## **UN/ECE/WP29/GRSP Pedestrian Safety gtr Informal Group 2nd Interim Report**

PROPOSED DRAFT GLOBAL TECHNICAL REGULATION (GTR)  
on  
PEDESTRIAN PROTECTION.

This document is a working document circulated for discussion and comments. It is only submitted with the intention to facilitate discussion by the GRSP Informal Group.

Figure 13: Windscreen test area.

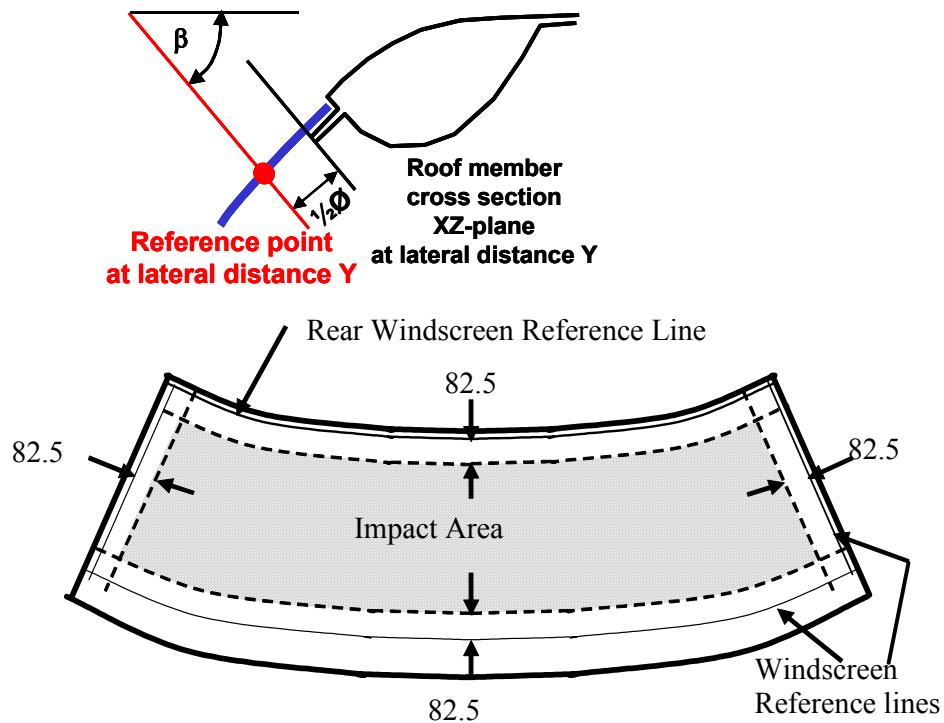
EU Comment: This diagram requires more discussion and agreement.

Figure 13b: windscreen side reference line

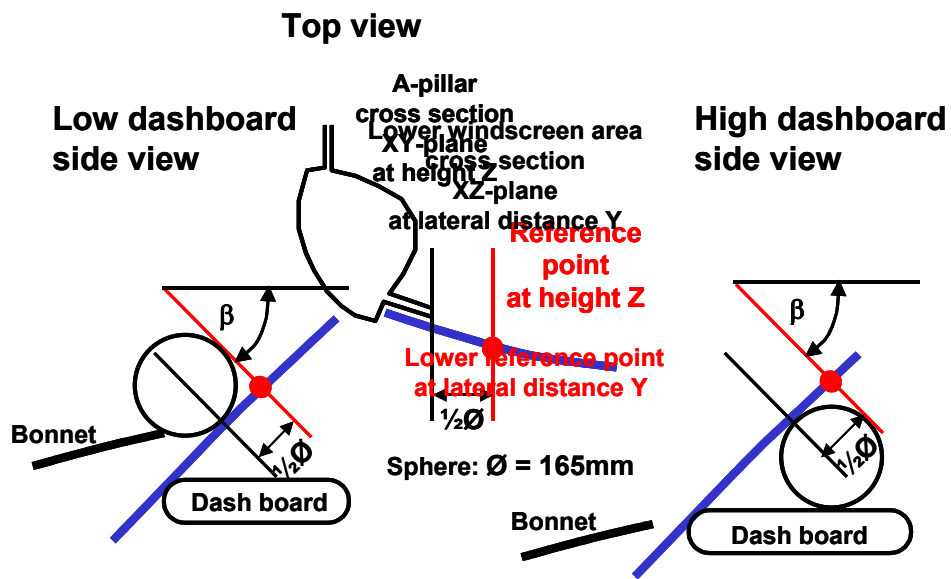
[EU Comment](#): This diagram requires more discussion and agreement.

[EU Comment](#): This diagram requires more discussion and agreement.
